VALUE ENGINEERING REPORT

**Busbee – Frey Connector
Cobb County
CCDOT Project No. CO – 400; PI No. 0010157**

February 21, 2012

Idea No.: C-1
Client: CCDOT
Sheet 2 of 8

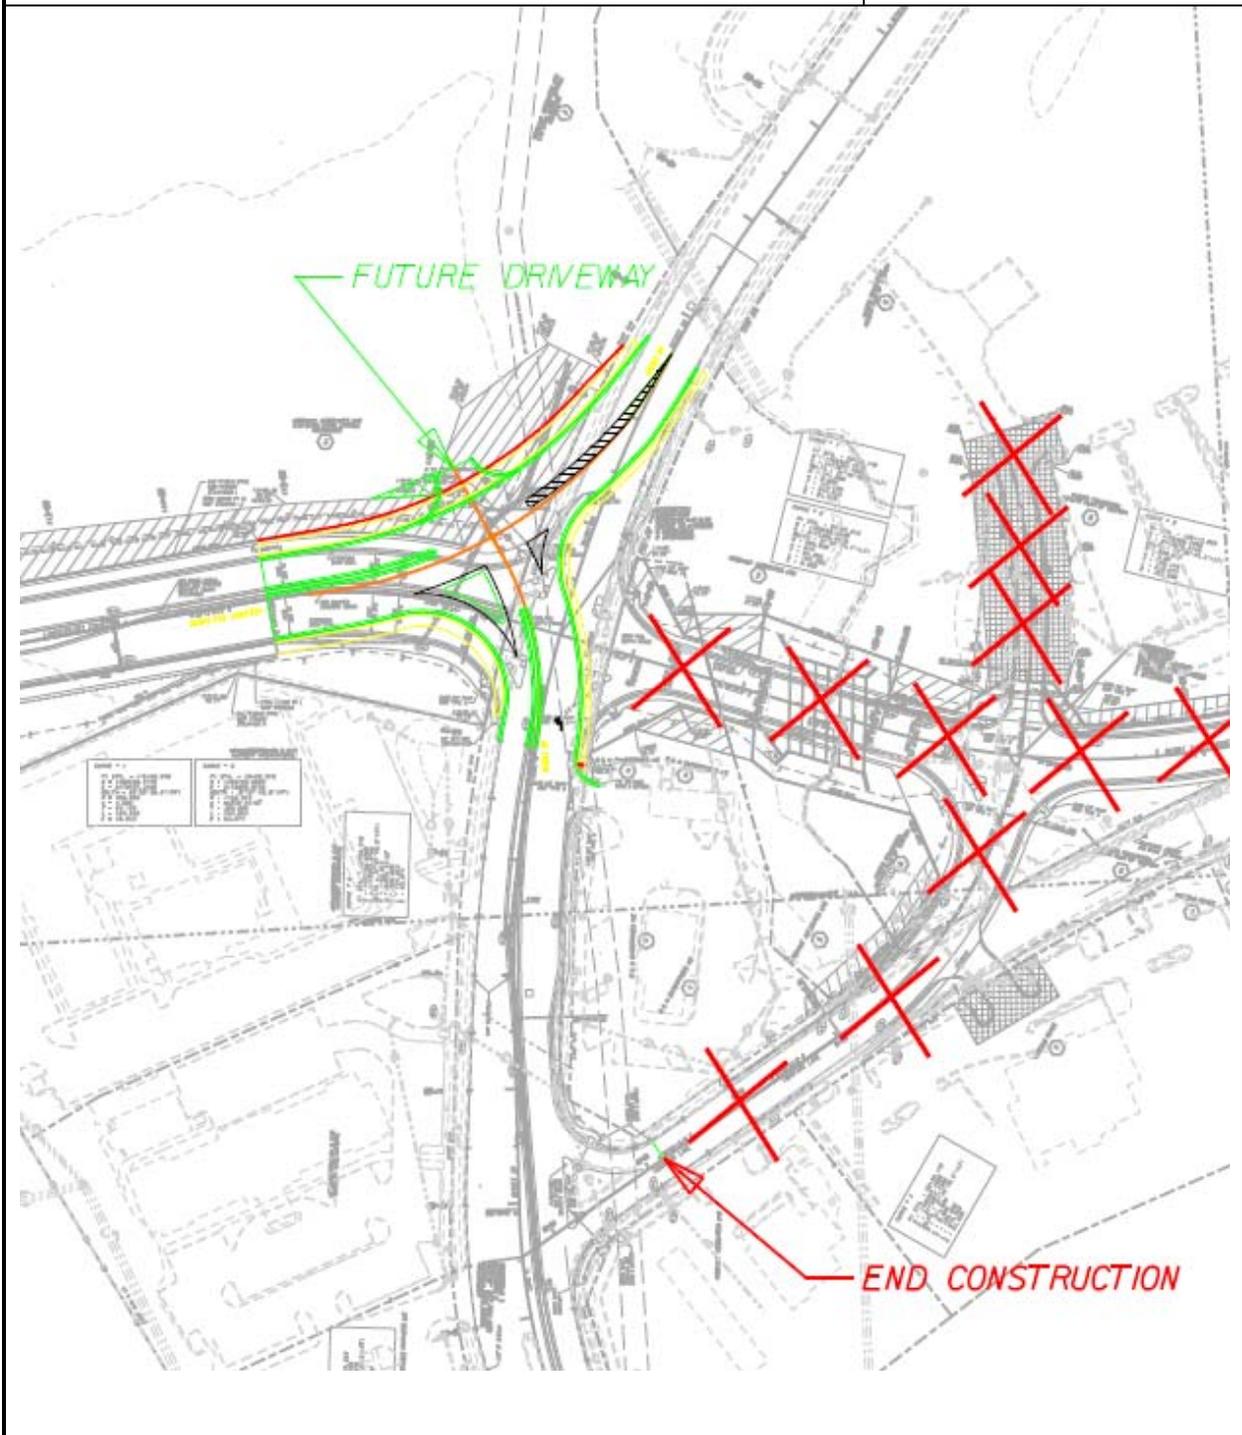
Extend Busbee-Frey Connector across I-75 and re-align with Busbee Drive to the existing T intersection with Busbee Parkway. This change eliminates the continued extension of the Busbee-Frey Connector across the regional detention pond, the six barrel box culvert, and the re-alignment of the eastern and western leg of Townpark Lane. The projected 2280 ADT (2034 Build) through vehicles would likely turn left at Busbee Drive and proceed to Busbee Parkway to disperse. There is adequate capacity on the existing roadway system to accept any redistributed traffic volumes.

Elimination of this portion of the Busbee-Frey Connector will reduce environmental mitigation, wetlands impacts, right of way, earthwork, paving, and drainage cost while not changing the project goal of reducing congestion on Chastain Road. These changes will likely eliminate the majority of wetland impacts and the associated environmental permitting. In addition, the impacts to the Zaxby’s detention pond and consequential replacement pond will be eliminated.

Based on our traffic analysis, the realigned roadway will operate at acceptable LOS' for both AM and PM peak design year hours. A dedicated right turn lane for access to the new slip ramp should be maintained and is included as part of this analysis. A continuous movement to Busbee Parkway could actually operate more efficiently for traffic on Buusbee Parkway, with the potential to eliminate the existing signal at Busbee Parkway and Townpark Lane.

An additional benefit of this recommendation is that it will allow a future driveway at the Busbee-Frey Connector / Busbee Drive intersection for the anticipated development for that corner property.

Idea No.: C-1.1
Client: CCDOT
Sheet 2 of 5

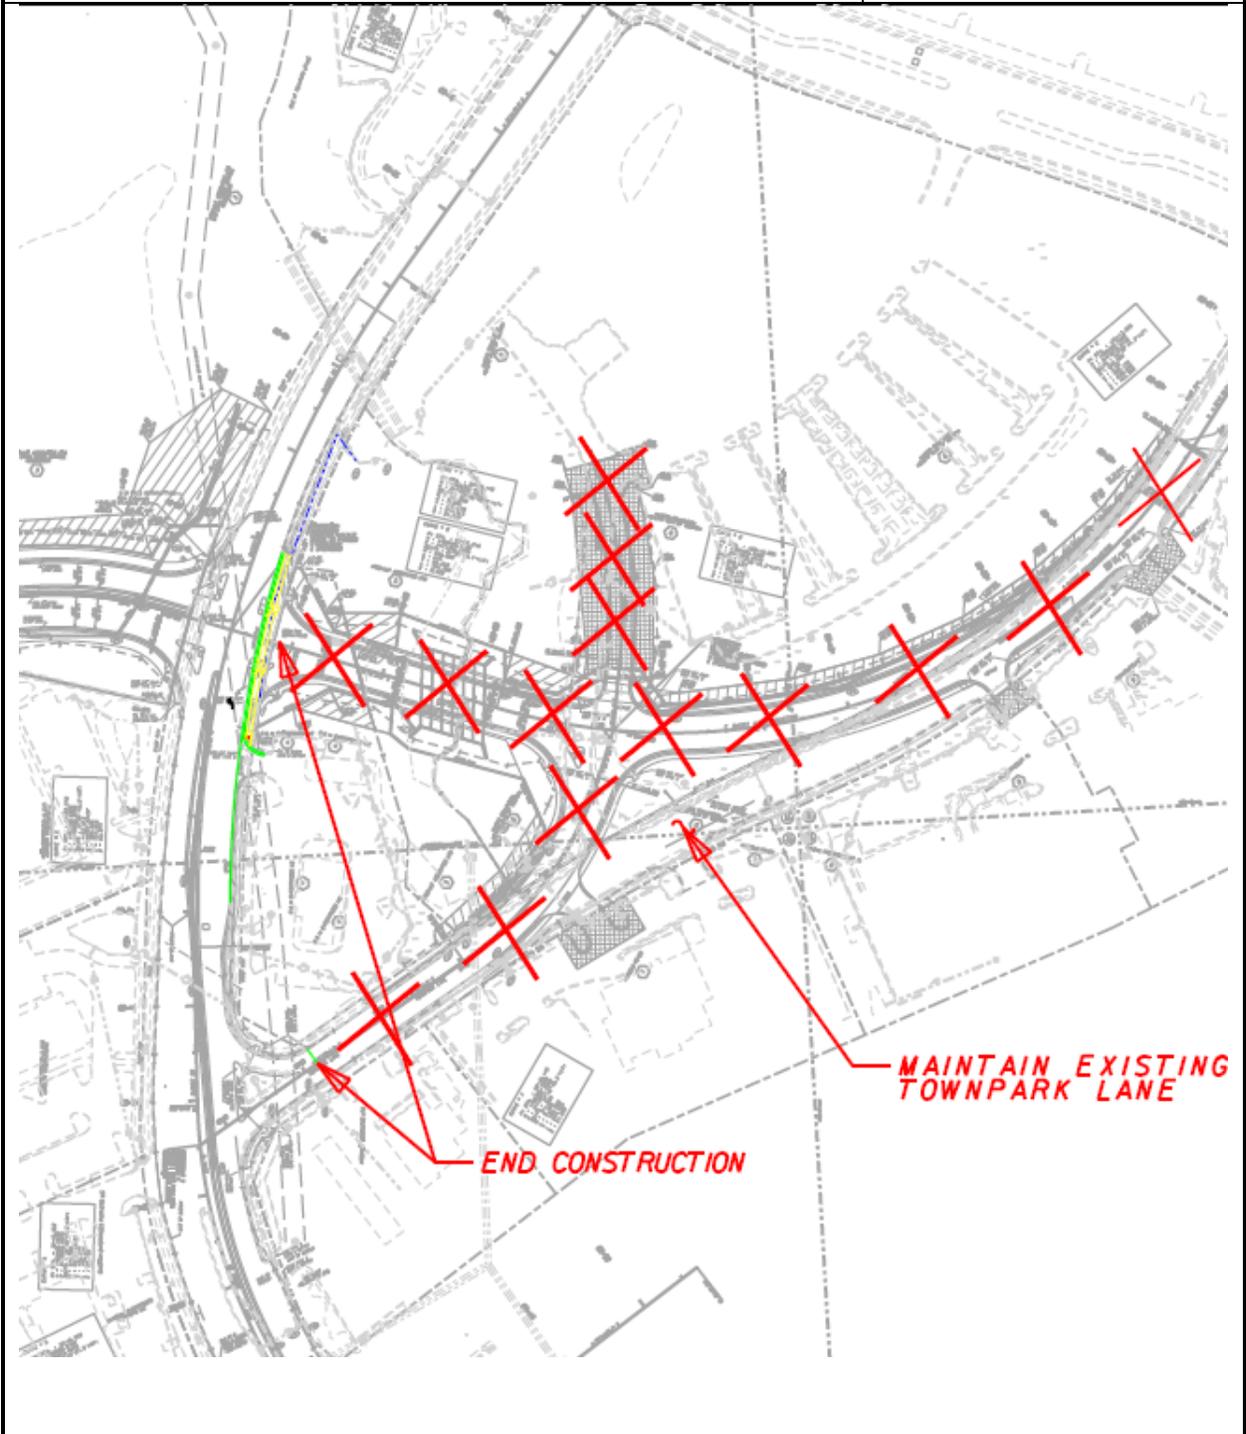
Extend Busbee-Frey Connector across I-75 to a T intersection with Busbee Drive. This change eliminates the continued extension of the Busbee-Frey Connector across the regional detention pond, the six barrel box culvert, and the re-alignment of the eastern and western leg of Townpark Lane. The projected 2280 ADT (2034 Build) through vehicles would likely turn left at Busbee Drive and proceed to Busbee Parkway to disperse.

**Idea No.: C-6
Client: CCDOT
Sheet 2 of 10**

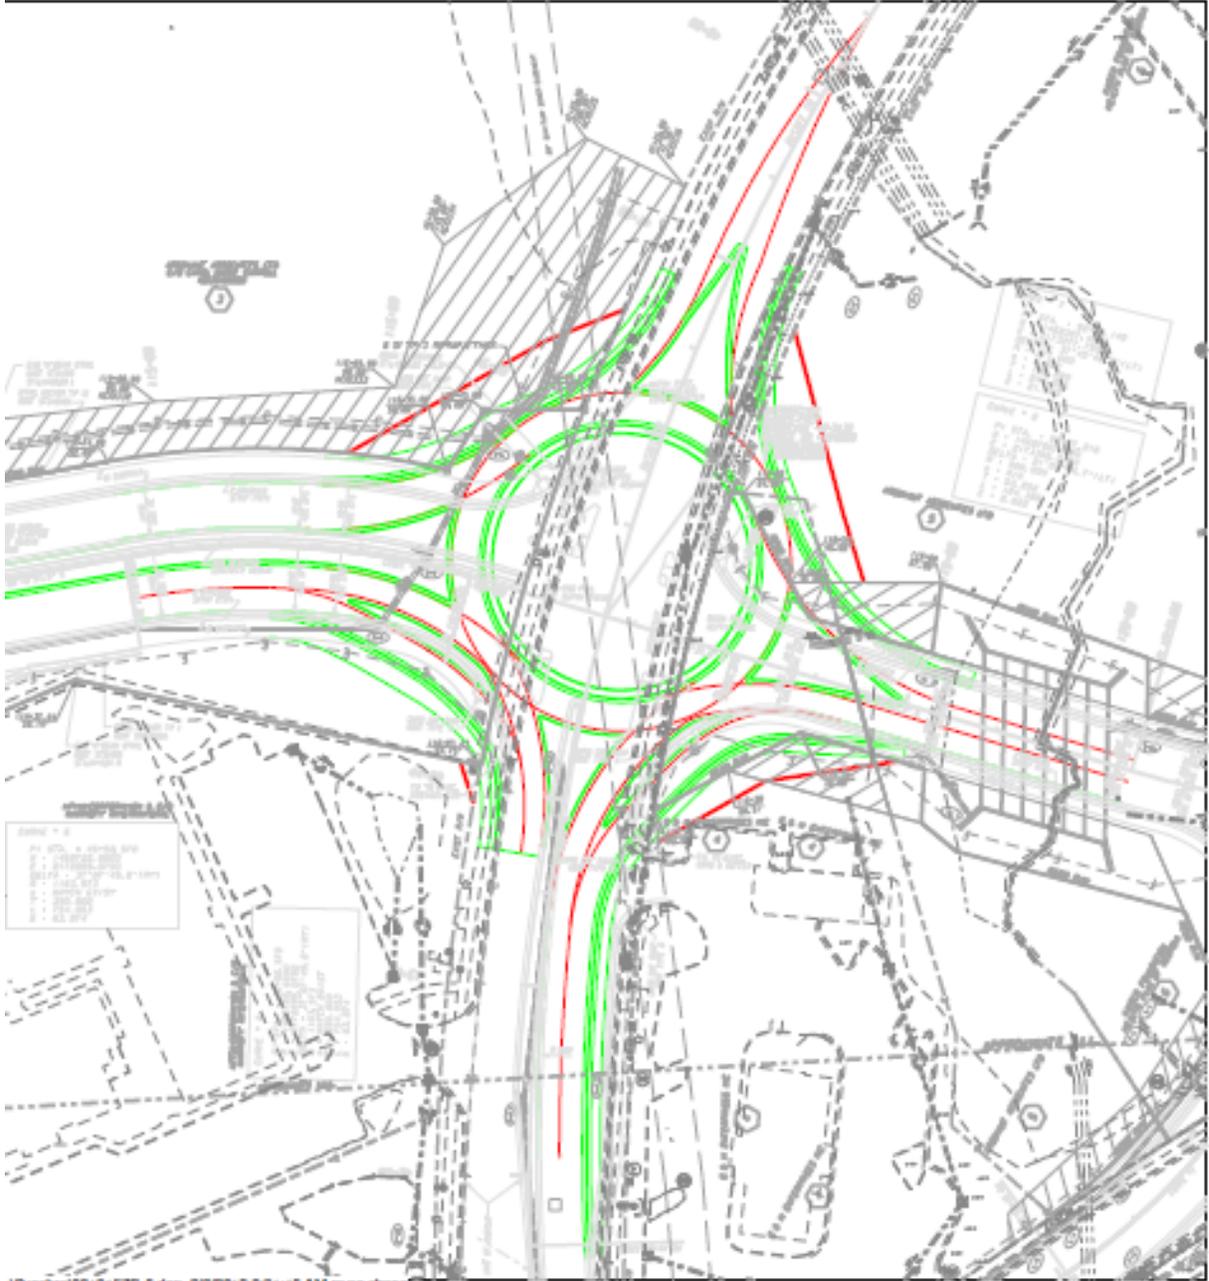
As part of the GDOT PDP process, any signalized intersection is required to have a roundabout analysis and based on GDOT's program, a roundabout performs at an acceptable LOS and reduces construction costs. It would also provide an opportunity for an enhancement of gateway feature.
